Project Name: Spot Bar
Project Address: 859 Randolph Avenue
Suite #/Campus: N/A
City Name: St. Paul
Applicant: Bruce Pastorius, Collective Carpentry

SPOT BAR	OUTDOOR LOUNGE
859 RANDOLPH AVE	8'X19' DECK
ST. PAUL MN 55102	10'X30' DECK
MERIDITH O'DOLE	37 LF PRIVACY FENCE
	P.I

CITY OF ST. PAUL	
REVIEWED FOR CODE COMPLIANCE	
ARCHITECTURAL	V-21-2094
DATE	12/13/2021 MD
STRUCTURAL	
DATE

REVISED PLAN 12/20/2021:
REDUCED SIZE OF PROPOSED
DECK TO 20' x 20'

SPOT BAR 859 RANDOLPH AVE ST. PAUL MN 55102 MERIDITH OTOOLE	SITE PLAN SCALE: 3/4" = 1'-0"
---	---

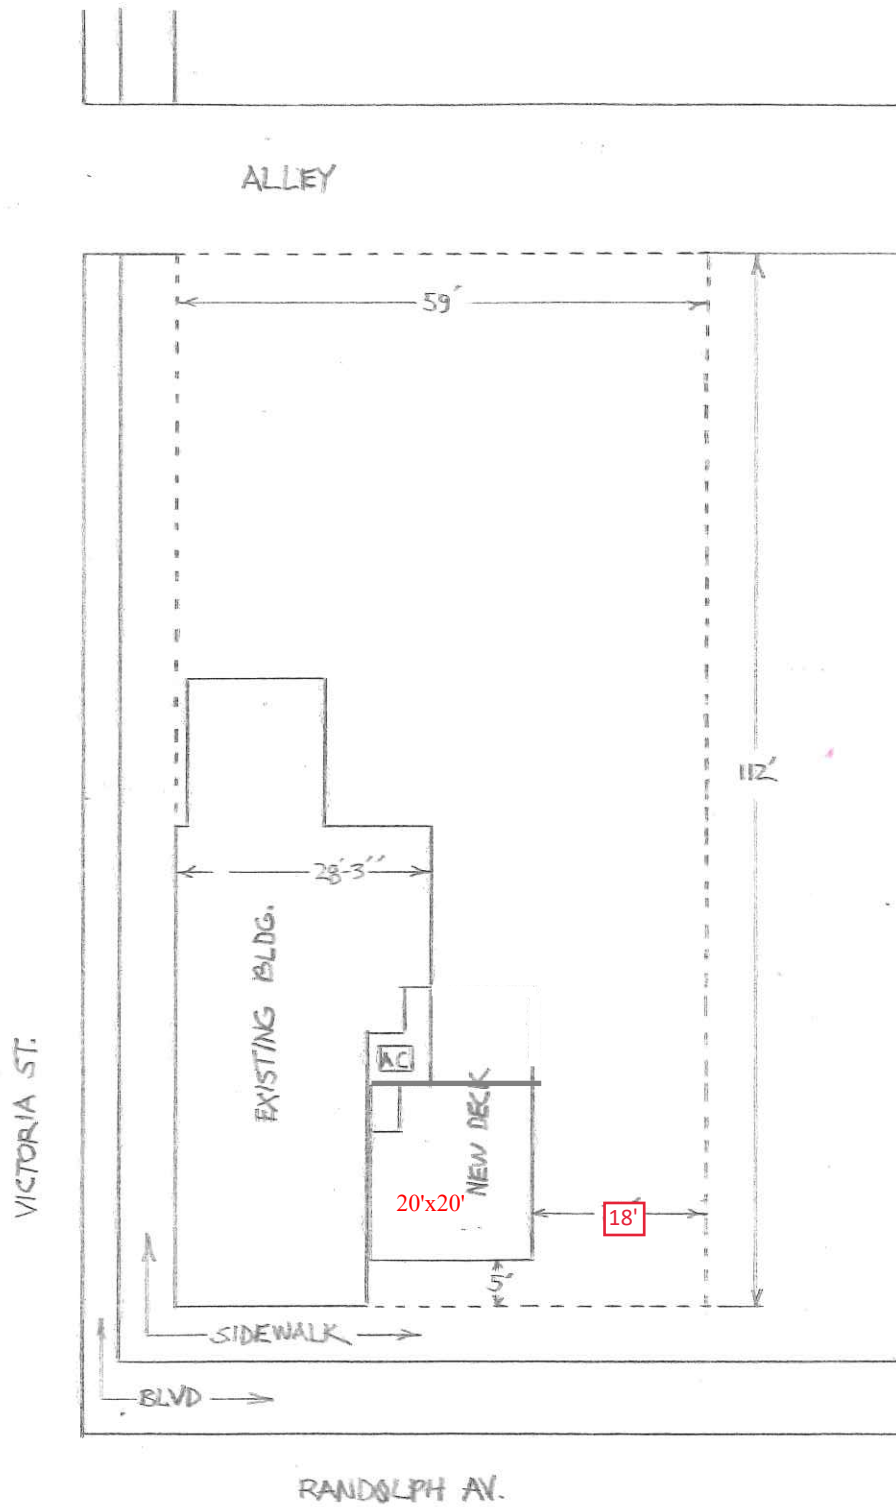
CHANGED TO 20x20 DECK WHICH
IS SMALLER THAN ORIGINAL DECK
PLAN, OK FOR PLAN REVIEW, STILL
NO SAC OWED.

TOP VIEW SCALE 1/4"=1'-0"

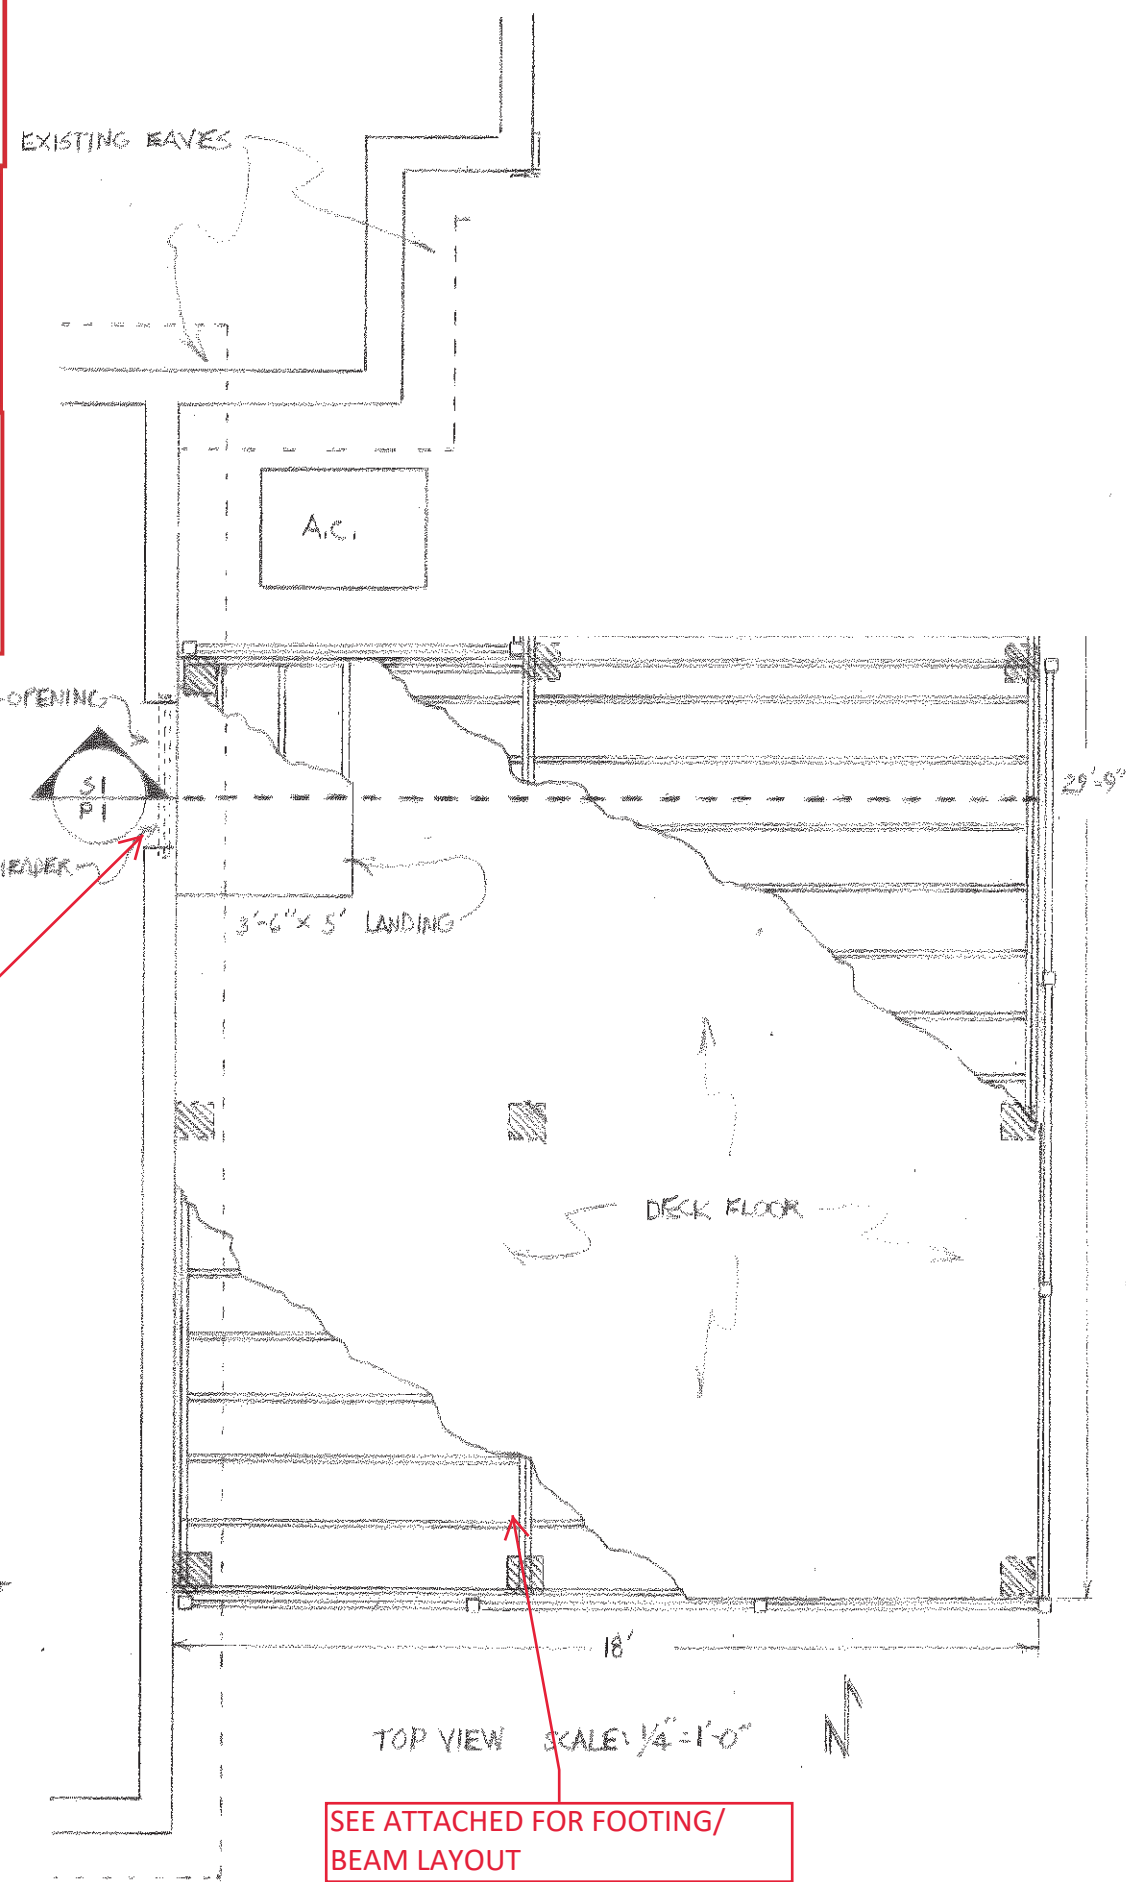
MN ACCESSIBILITY CODE COMPLIANCE REQUIRED. INSTALL EXACTLY PER CODE. ALL ERRORS MUST BE CORRECTED.

SECTION S1 P1 SCALE 1/2"=1'-0"

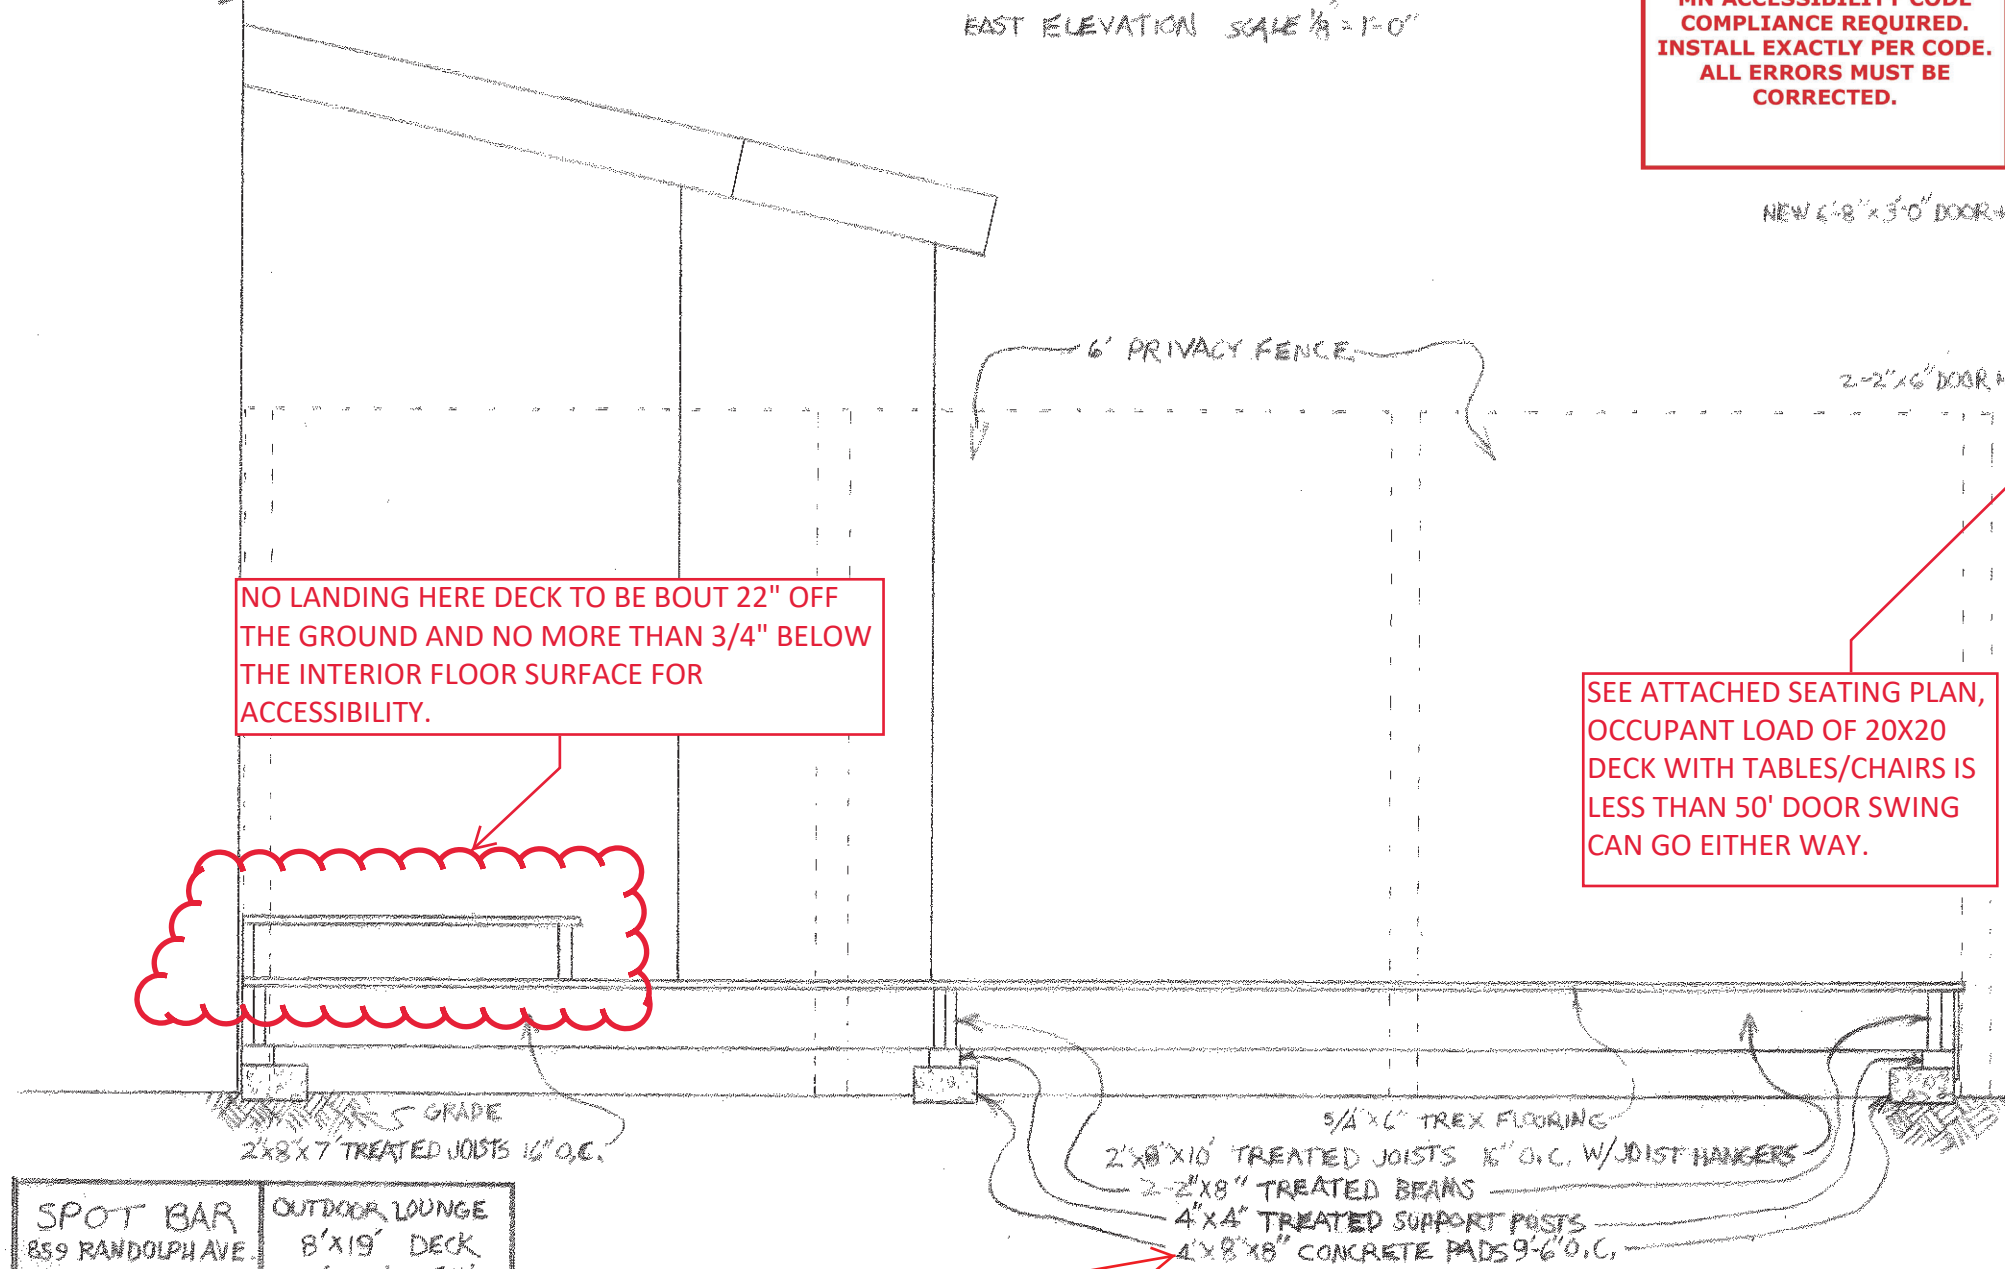
NO LANDING HERE DECK TO BE BOUT 22" OFF THE GROUND AND NO MORE THAN 3/4" BELOW THE INTERIOR FLOOR SURFACE FOR ACCESSIBILITY.

SEE ATTACHED SEATING PLAN, OCCUPANT LOAD OF 20X20 DECK WITH TABLES/CHAIRS IS LESS THAN 50' DOOR SWING CAN GO EITHER WAY.

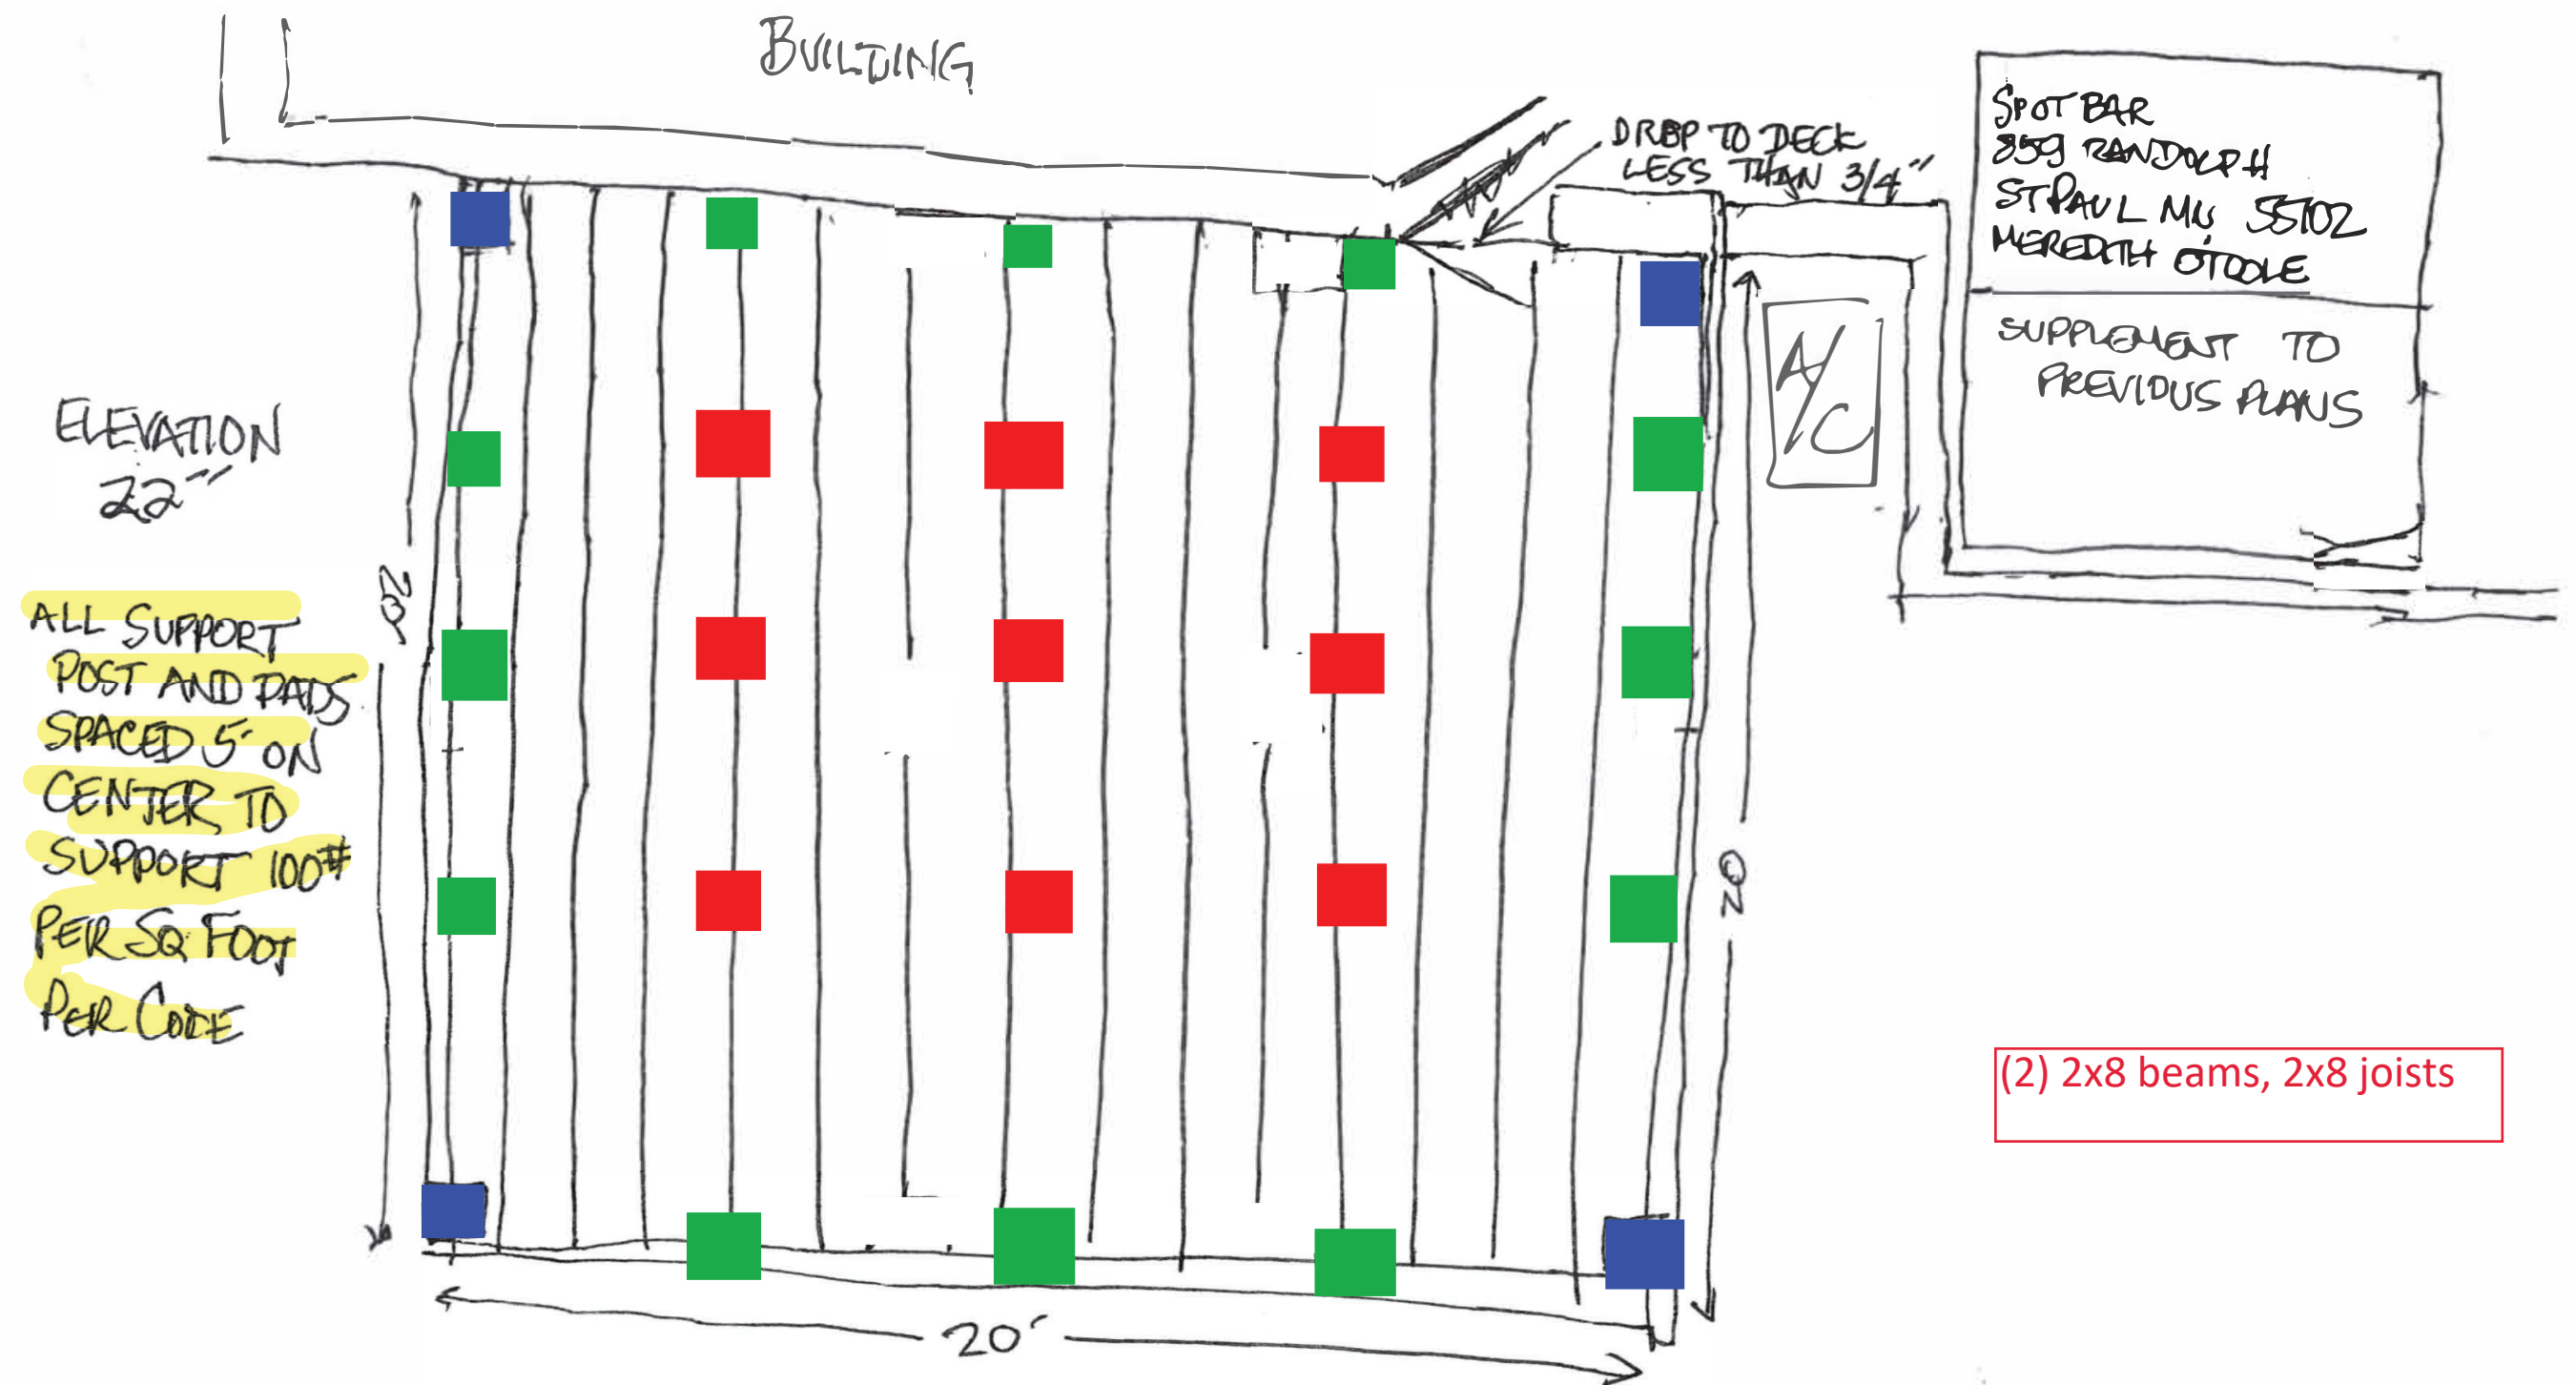
ALTERNATE ACCEPTABLE FOOTING LAYOUT: FOR A DECK USING 8"X8" PRECAST FOOTINGS, TRIBUTARY AREA FOR EACH FOOTING WOULD BE A MAXIMUM OF 9 SQUARE FEET (FOOTINGS WOULD NEED TO BE IN PLACE EVERY 3' FEET IN A GRID PATTERN MINIMUM OR EQUIVELANT).

- = RED FOOTINGS; SUPPORTING 2500 LBS, SIZE 14"X 14" PAD FOOTING MINIMUM
- = BLUE CORNER FOOTINGS, SUPPORTING 625 LBS, 8" X 8" PAD FOOTING MINIMUM
- = GREEN OUTER FOOTINGS, SUPPORTING 1250 LBS, 11"X 11" PAD FOOTING MINIMUM
